SERVICE BULLETIN

IDENTIFICATION AND POSSIBLE REWORK OF SEAT BELT AND SHOULDER HARNESS ASSEMBLIES

All Model 369H Series Helicopters

SERVICE BULLETIN NO. CP-1002

Figure 1. Identification of Reworked Seat Belt Assemblies

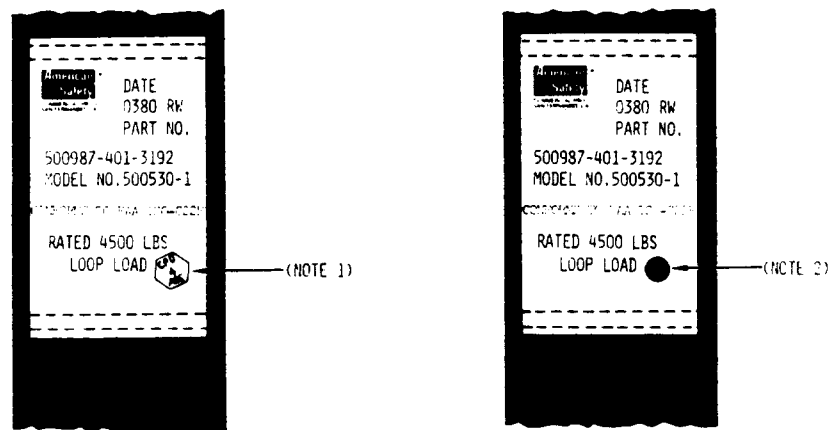
- a. Visually determine whether seat belt and shoulder harness assemblies are manufactured by American Safety Equipment Corporation. See Figure 1 and refer to attached ASEC Service Bulletin No. CP-1002 for product identification data and parts/assemblies affected.

If seat belt assemblies are manufactured by American Safety Equipment Corporation, and seat belt tag (See Figure 1) has green hex-shaped stamp, perform step d only.

- b. As required, rework American Safety lap belt assemblies per attached Service Bulletin No. CP-1002.
- c. Apply 3/8 - inch green dot on tag at location shown in Figure 1.
- d. Record compliance with this Service Information Notice in Compliance Record of helicopter Log Book.

1. GREEN HEX-SHAPED STAMP DENOTES LAP BELT ASSEMBLY REWORKED BY AMERICAN SAFETY EQUIPMENT CORPORATION (NO FIELD REWORK REQUIRED).
2. GREEN DOT DENOTES LAP BELT ASSEMBLY REWORK ACCOMPLISHED PER THIS NOTICE.
